CITY OF ALBUQUERQUE

PLANNING DEPARTMENT – Development Review Services

**RE: Morningstar at Palomas
Grading and Drainage Plan with Supplemental Drainage Calculations
Engineer's Stamp Date (9-5-14) File: D19D029**

GRADING & DRAINAGE PLAN-NW

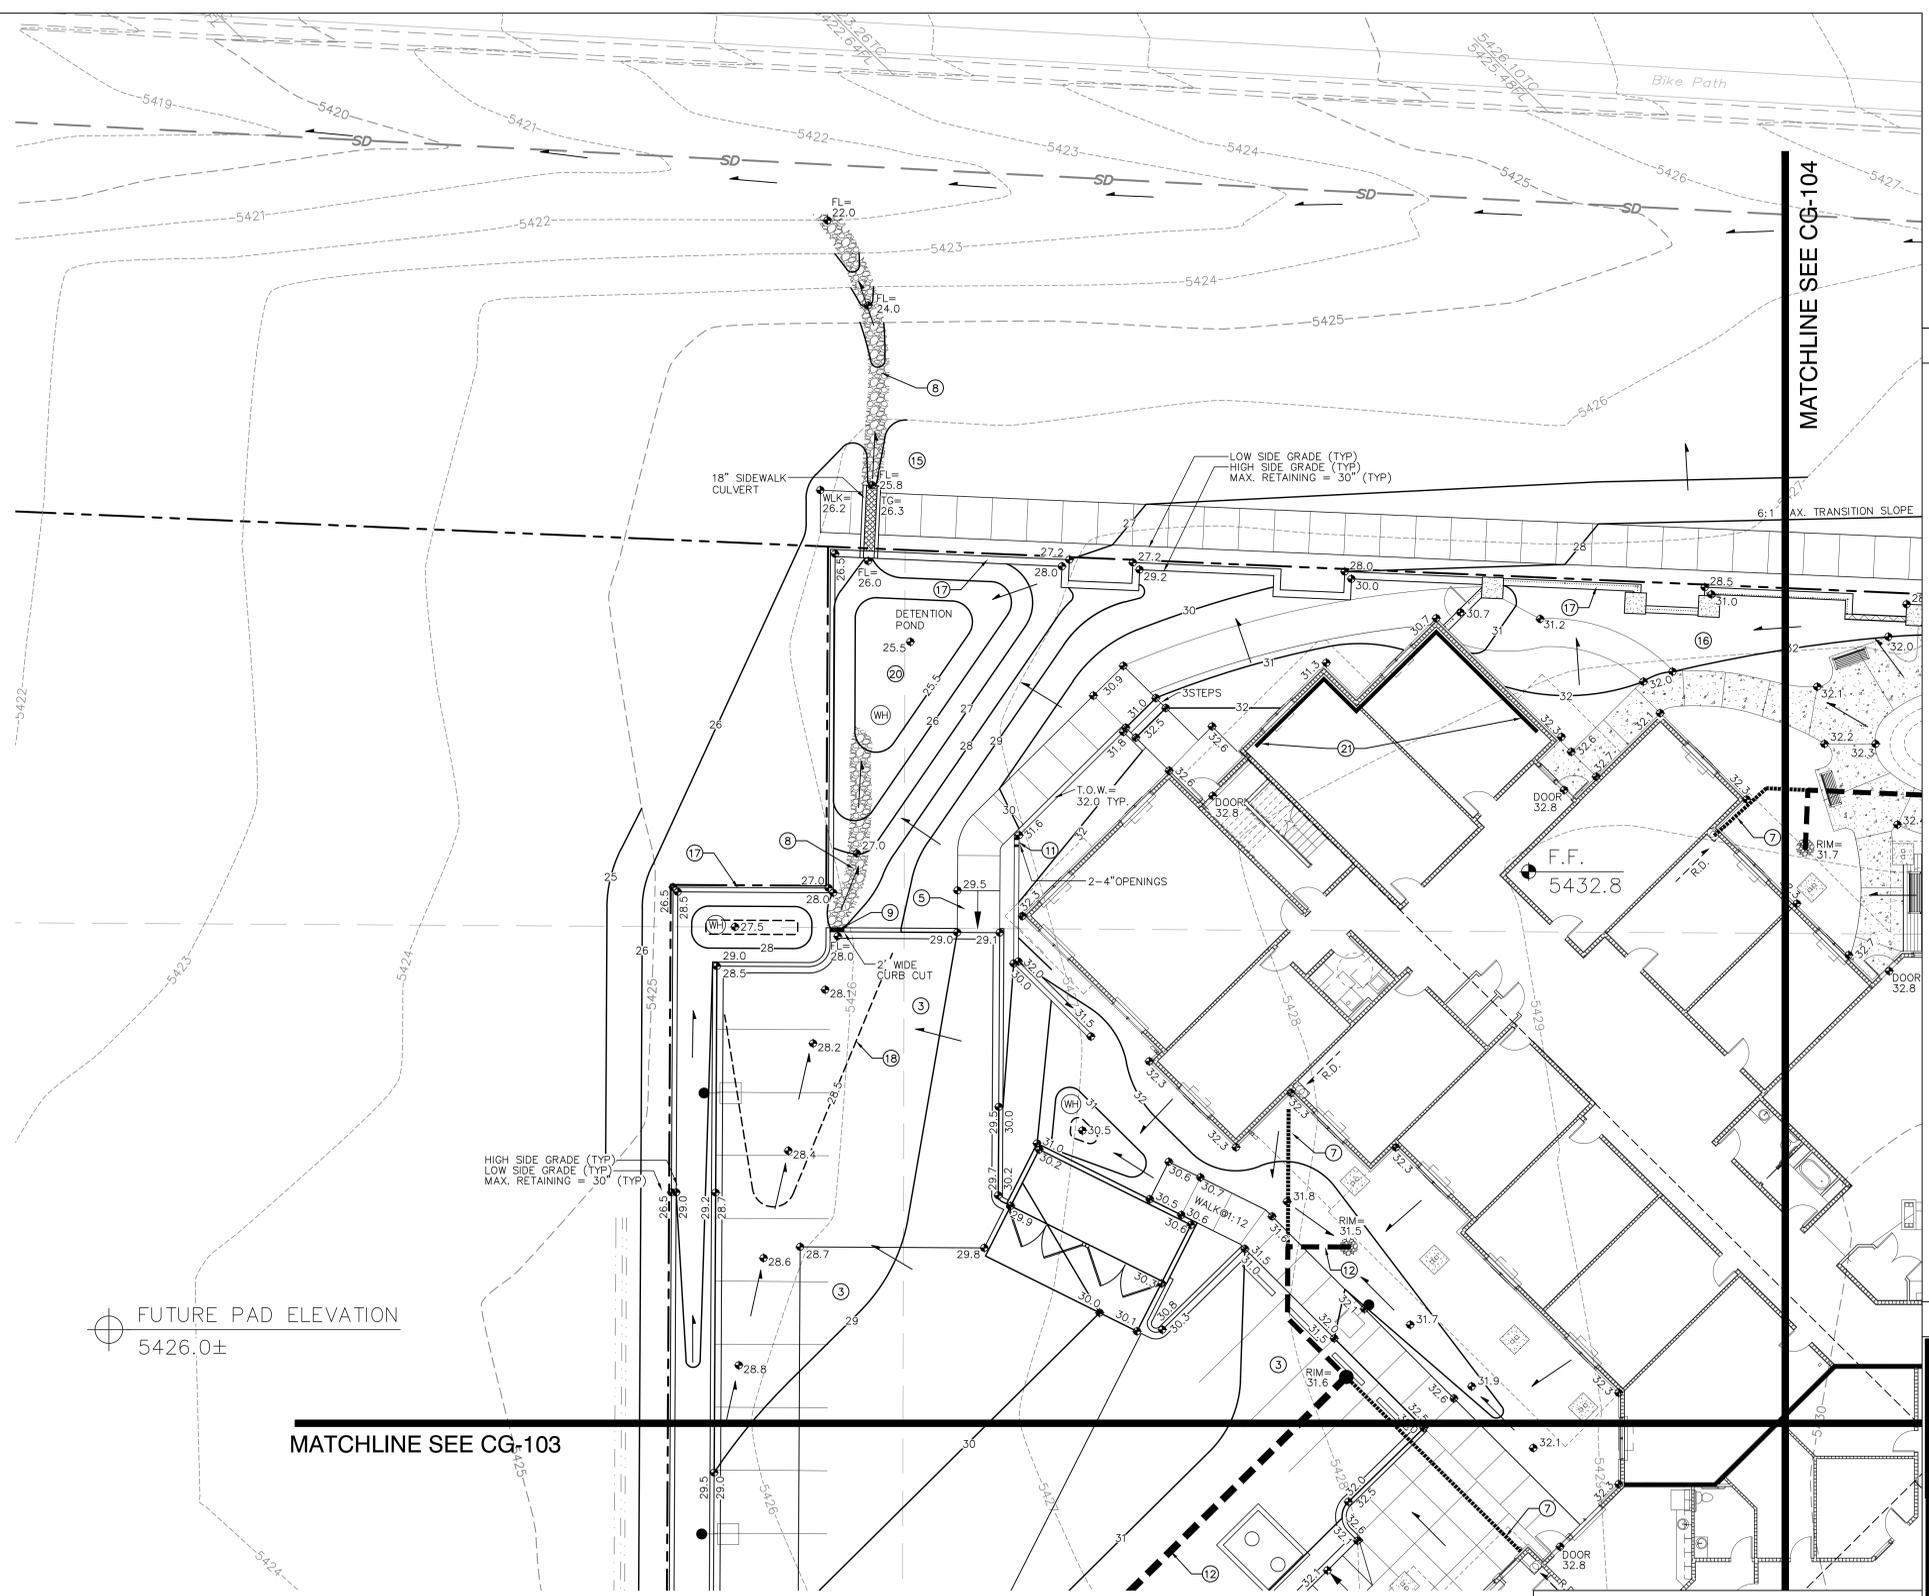
3. Sheet CG-102, at the sidewalk behind the trash enclosure, the grade falls at more than a 2:1 slope (from 32' contour to 30.7 T.O. SW). At end of SW, the grade gets higher right before the water harvest pond. The inlet should be in a sump condition so that runoff does not bypass inlet and flow into Basin 10.

4. Along the same note, it seems that another roof drain is needed on the SW corner of the building so that all of Basin 9 (roof) does not discharge to Basin 10 and ultimately NMDOT ROW.

5. A SW culvert is needed at the private pedestrian walkway where it connects to the public sidewalk, allowing runoff to flow directly to pond.
6. On major ponds in NE, NW, and SW corners, label the WSEL, Pond Volume, and Emergency Overflow.

**NYLOPLAST BASIN DESIGN INFORMATION**

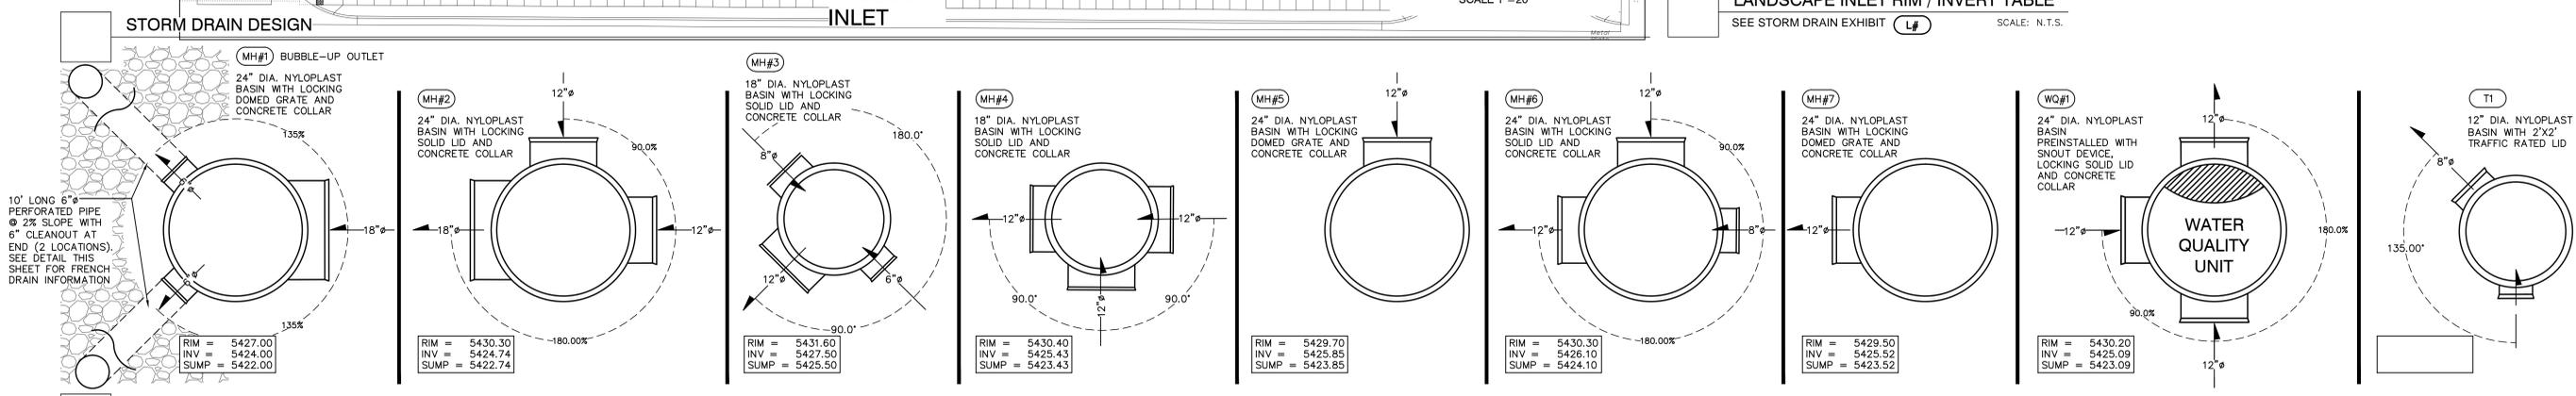
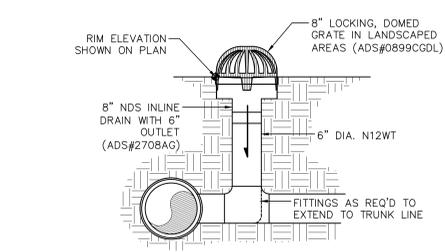
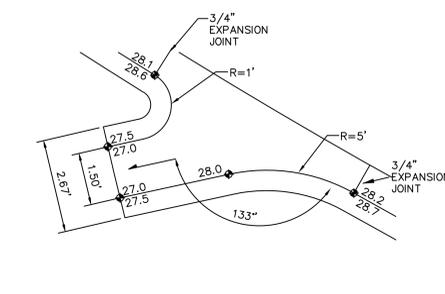
1. Calculations of NE Pond Outlet pipe to Paseo Del Norte use a 4" dia. pipe to restrict flow to 0.7 cfs, using a 3' head (pg.8). However, Plan Sheet CG-501 show a 8" dia. pipe, and the MH#7 detail shows a 12" dia pipe. Also, invert elevation (2425.52) and Pond WSEL elevation (2431') indicate a head of 5.3' should be used instead. Since 4" pipe is already pretty small, and head is already over, how can you meet the 0.7 max. cfs.
